**Subject: Docket Nos. 50-361 and 50-362
Proposed Change Number (PCN)-548, Revision 1
Battery and DC Sources Upgrades and Cross-Tie
San Onofre Nuclear Generating Station, Units 2 and 3**

SUBJECT: Proposed Change No. 548, Rev. 1, is a request to revise Technical Specifications (TSs) 3.8.1, "AC Sources – Operating," 3.8.4, "DC Sources – Operating," 3.8.5, "DC Sources – Shutdown," 3.8.6, "Battery Cell Parameters," 3.8.7, "Inverters – Operating," and 3.8.9, "Distribution Systems – Operating." This change will also add a new Battery Monitoring and Maintenance Program, section 5.5.2.16. This change will extend the Completion Time for an inoperable subsystem battery by allowing manual cross-connect of distribution subsystems, upgrade to the 2002 Revision of IEEE 450, include improvements included in Revision 1 to Technical Specification Task Force (TSTF) – 360, and make editorial modifications more consistent with industry use.

Attachment 2: DC System Configuration Diagrams (Sketch 1 and 2)

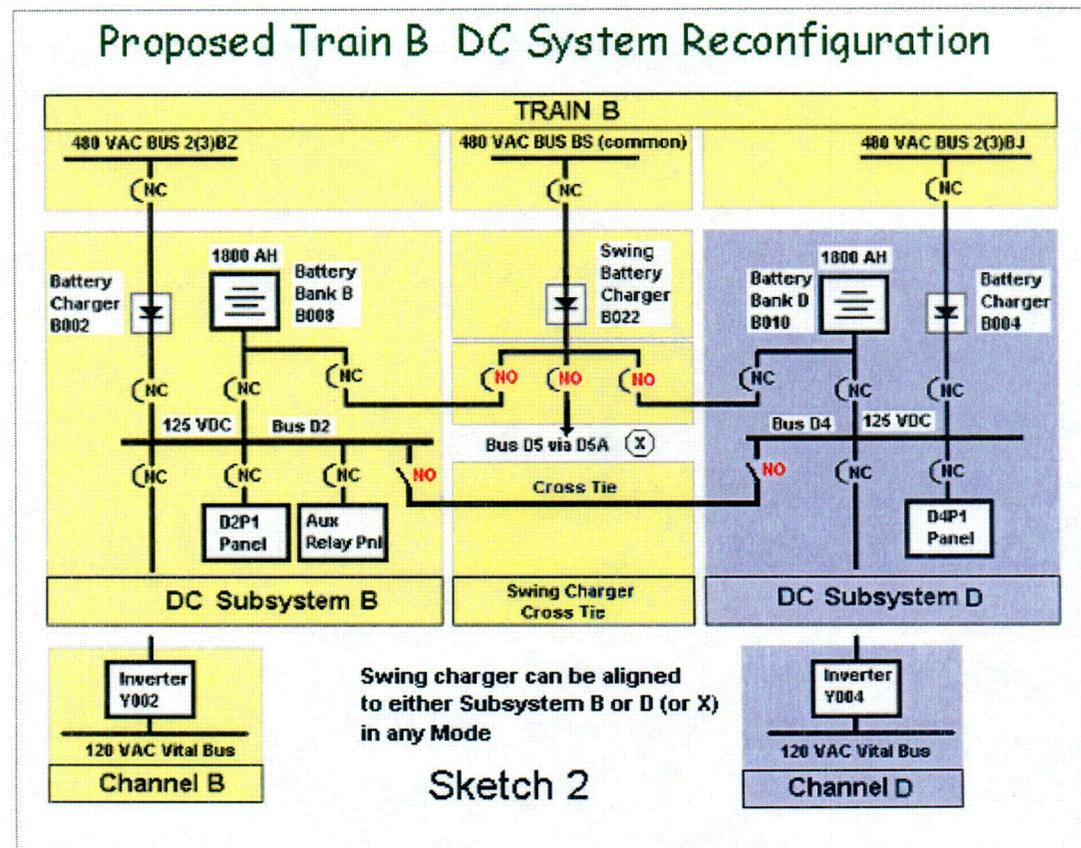
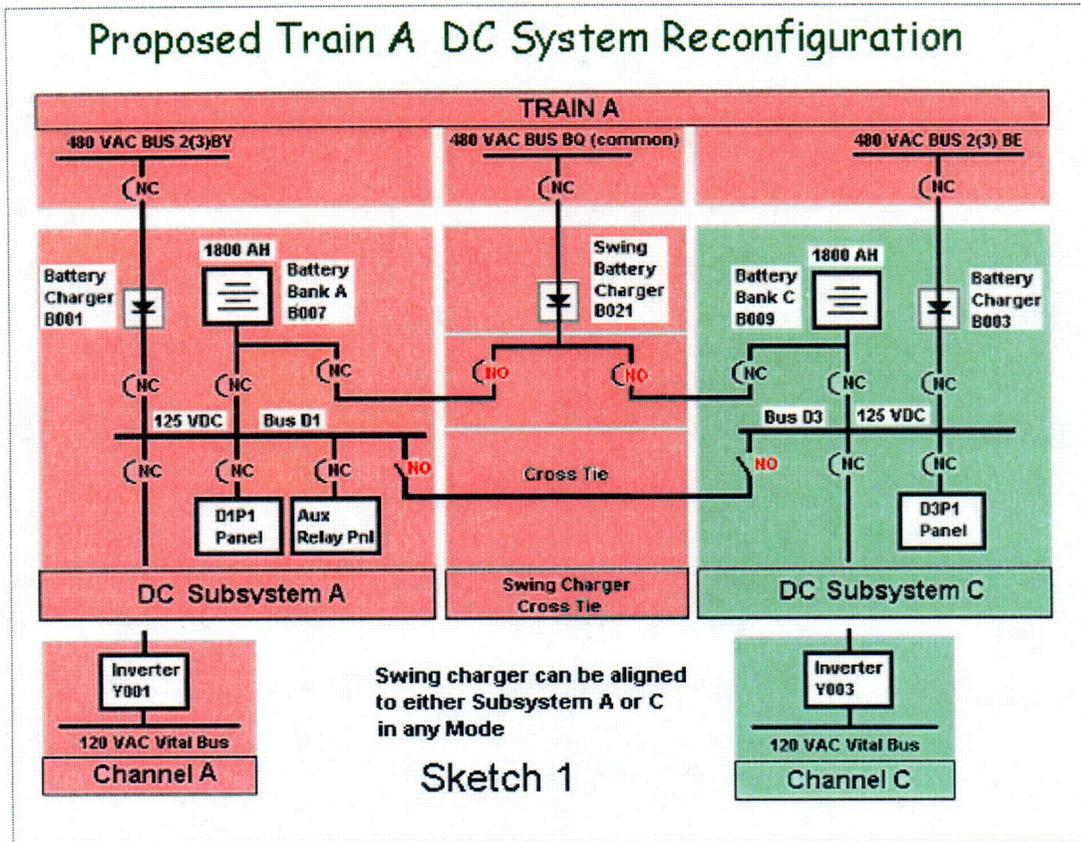
To be able to fully utilize the flexibility provided by the proposed TS, design changes are currently being made to the electrical system to provide the ability to manually cross-connect DC subsystems during operating Modes 1-4 and continue to meet General Design Criteria (GDC) 17, GDC 18, Regulatory Guide (RG) 1.6, and IEEE 308. These design changes include one new swing battery charger to be shared by subsystems A and C and another by subsystems B, D, or non-1E bus D5. Electrical isolation and independence between subsystems required by RG 1.75 is maintained by the isolation capability of the battery charger itself and the kirk key interlocked output circuit breakers. The existing batteries for each train are being replaced with batteries with 1800 amp-hour ratings. (Refer to Sketches 1 and 2 of the post-modification system in Attachment J, Review Aid). Currently, the subsystems A and B batteries are rated 1260 amp-hours nominal 8-hour, and the subsystems C and D batteries are rated 1800 (previously 1500) amp-hours nominal 8-hour.

During Mode 1-4 cross-connect configurations, as needed by maintenance activities or for corrective activities, administrative controls will be in place to ensure that the required battery chargers are operable. The new swing charger will provide added flexibility to either supply a discharged battery or to supply the cross-connected distribution systems or to replace a normal battery charger should the normal battery charger become unavailable. The two batteries will not continuously operate in parallel supplying the cross-connected distribution system.
